Restoration of a Micro Hydro Scheme on the River Gynack

Variation to application 10/424/CP to add a Coanda screen, delete the lade and alter the position and construction of the turbine building.

Design proposal

Kingussie Community Development Company

Fig 13

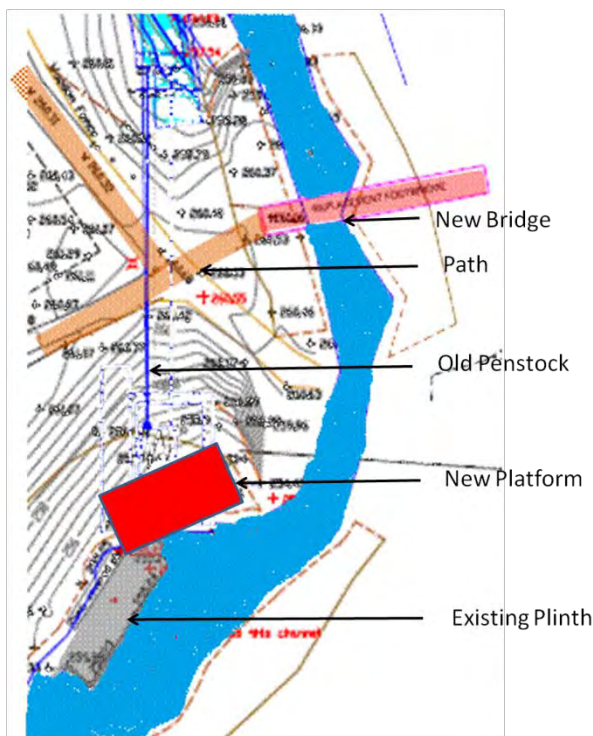
The proposed location of the new powerhouse relative to the existing plinth and old penstock is shown in Figure 13. It is mounted on a platform and contains the turbine, generator and associated control equipment.

Fig 16

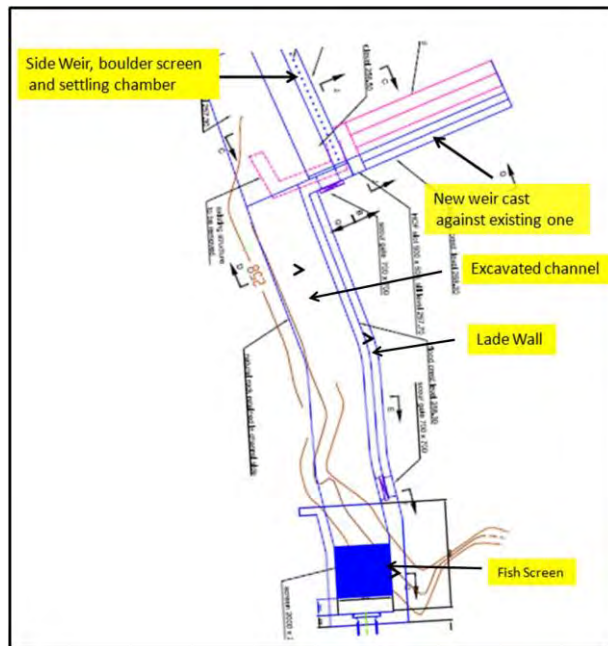
The approved scheme has a 5m long concrete side weir on which is mounted a 200mm high steel boulder screen. It discharges into a settling chamber that in turn feeds a 15m long lade. This is 2m wide and has a wall facing the river which is 1.5m high in places. The lade contains a fish screen angled in order to meet the SEPA requirements for limiting maximum water velocity. The surface finish of this structure is of concern from a planning perspective. All of the above will be deleted. See plan and sections drawing nos 2096/1 and 2096/5A submitted to CNPA on 17th May 2013. An extract of this is shown in Figure 16 below with the existing weir and intake structure shown in red and the additions in blue.

fig 17

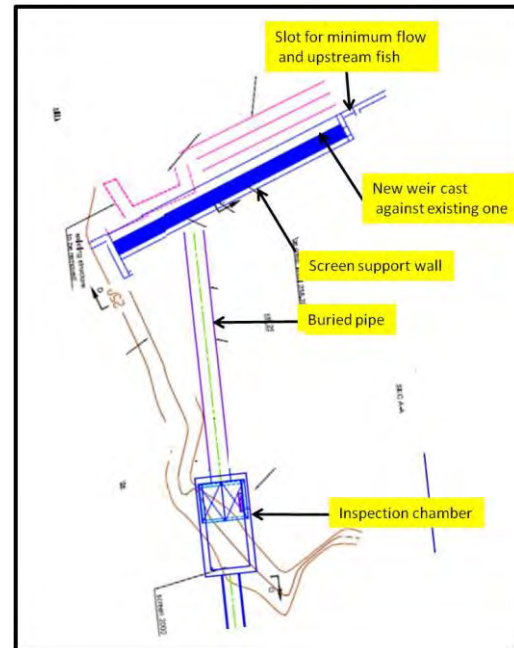
The new weir face will be extended across the full width as explained in section 2 above and shown in the section in Drawing KCDC/13/02 in Appendix 2. A plan for comparison with the approved scheme is shown in Figure 17 above. Details of the support wall and pipe connection are also shown in that drawing. Coanda screens are accepted by SEPA for protection of downstream fish passage. The detail of the screen is shown in Drawing F-1500 HC. It is constructed in stainless steel sections 1.5m wide that are bolted to the weir and support wall. 6 sections will be installed with a design capacity of 480 l/s and head loss of 450mm. Screens can be individually removed for maintenance. Depending on the progress with the Pitmain hydro schemes that may reduce the frequency and magnitude of spates, protection bars may be installed as shown in drawing F-1500.

Fig 19

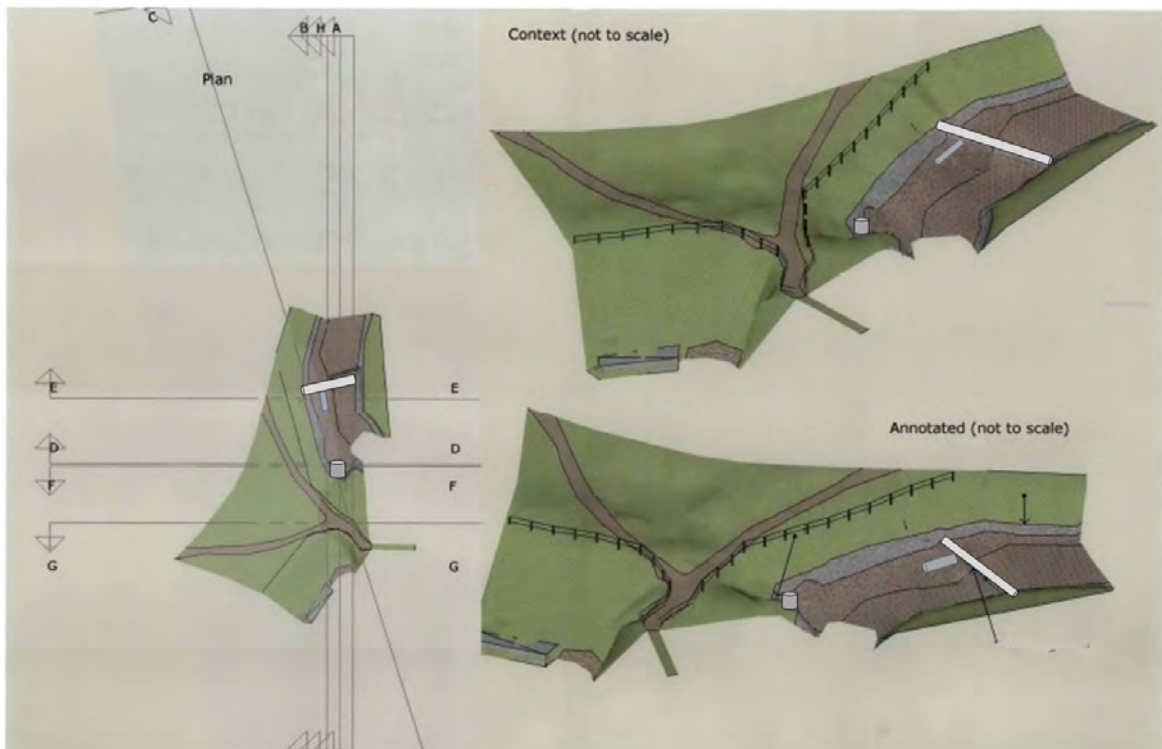
The undeveloped state of the site in dry conditions is shown in Figure 1. This has been modified approximately to reflect the current proposals for the intake and is shown in Figure 19.

Fig 20

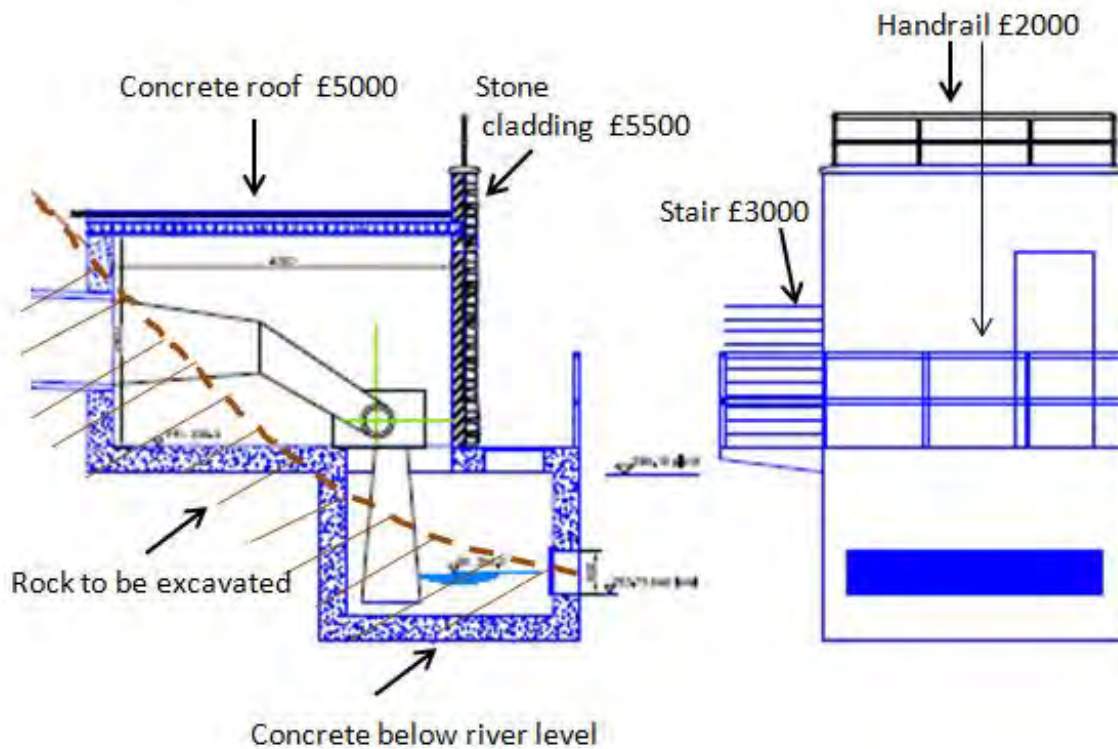
The cost of the powerhouse was a major factor in the decision to abandon the approved scheme. Significant elements of that cost, as summarised in Figure 20 below were:

- Provision of a flat roof as a viewing platform with handrails
- Natural Stone cladding of the walls
- Concrete stairs
- Significant requirement for excavation of rock
- Significant requirement for concrete to be cast below the water level.

The first item was a legacy of when the Archimedes screw powerhouse roof was at the same elevation as the new bridge and was part of the access route to it. It is unnecessary. A pitched roof clad with metal profile sheeting of an appropriate colour is proposed

Fig 21

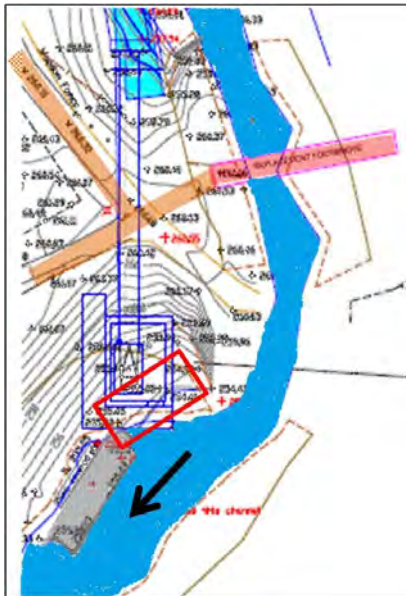
Significant excavation of rock can only be avoided by moving the location of the powerhouse. Figure 21 shows a plan of the proposed new position in red superimposed on the position proposed for the approved scheme in blue. Note that the final position and orientation of the platform will be dependent on site conditions and requirements for matching to the turbine. The position and orientation may vary up to 1m in any direction. The final position will be shown on the drawings submitted before construction. The line of the penstock through the outcrop is unchanged from the approved scheme but an additional bend will be required. This will be visible externally.

fig 22

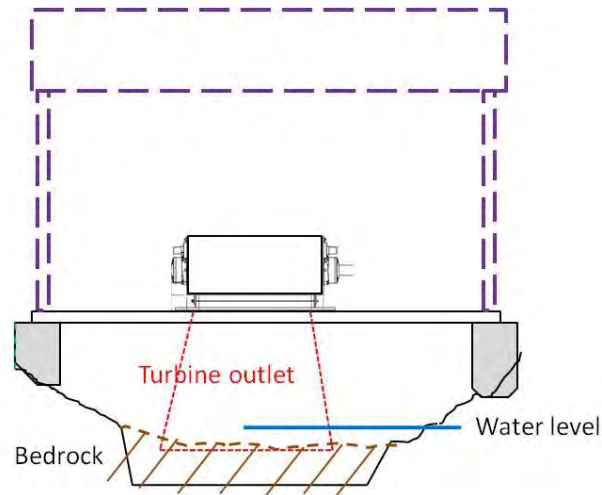
Significant savings can be made by avoiding the requirement for an enclosed concrete tailrace chamber and discharging into an excavated rock chamber that connects via a natural rock cill (if possible) to the original outwash position as shown in fig 22.

Fig 24

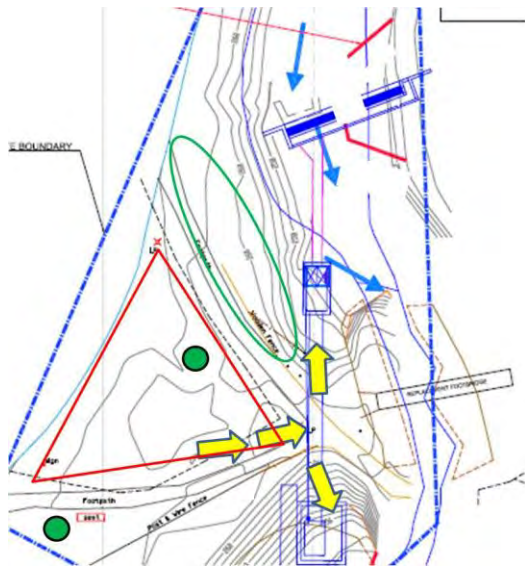
In order to minimise disruption on the public road contractors will use the Golf Club car park as shown on the Location Plan in Appendix 1. The triangular area shown in Figure 24 will be used for temporary storage of excavated materials and for access to the works. Any soil and ground flora will be stored separately in order that it can be reused. A tree survey has been done and the two trees (Oak of girth approximately 2.5m and Birch of girth approximately 1m) marked in green on Figure 24 will be protected. Other small trees, which are a mixture of birch, hazel, alder and rowan will be protected where practicable. In particular it is proposed to avoid removing the trees between the path and the river shown in green on the plan unless essential. Access to the works will be as shown by the yellow arrows.

Figure 24 shows a plan of access to the site that minimises the need to remove trees. The disturbed ground around the site of the lamppost will be lowered to permit digger access and reinstated afterwards. KCDC woodland and biodiversity group will manage the restoration of this ground through re-establishing the dominant ground cover and planting native trees to replace any that need to be removed for access.

fig 25

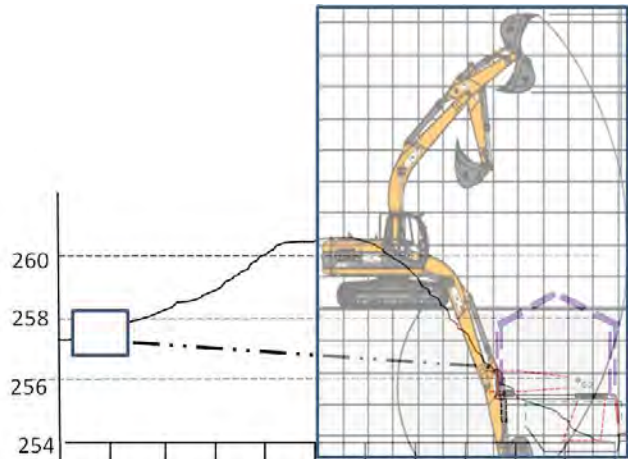
In order to access the works safely, the disturbed ground along the line of the old penstock will be temporarily lowered to provide a platform as shown in Figure 25. Up to 40m³ of material may need to be moved. This will be reinstated to leave the path profile approximately as it is at present and to retain accessible access. Waste disposal will be minimised as far as practicable by segregating reusable material. The Civil Engineering contractor will complete this work to the satisfaction of KCDC who will then through their Paths sub-group and Woodland and Biodiversity sub-group reinstate paths, fences and ground cover. The ability of KCDC to perform this work to a high standard can be seen in the recent improvements to the woodland downstream of the site.
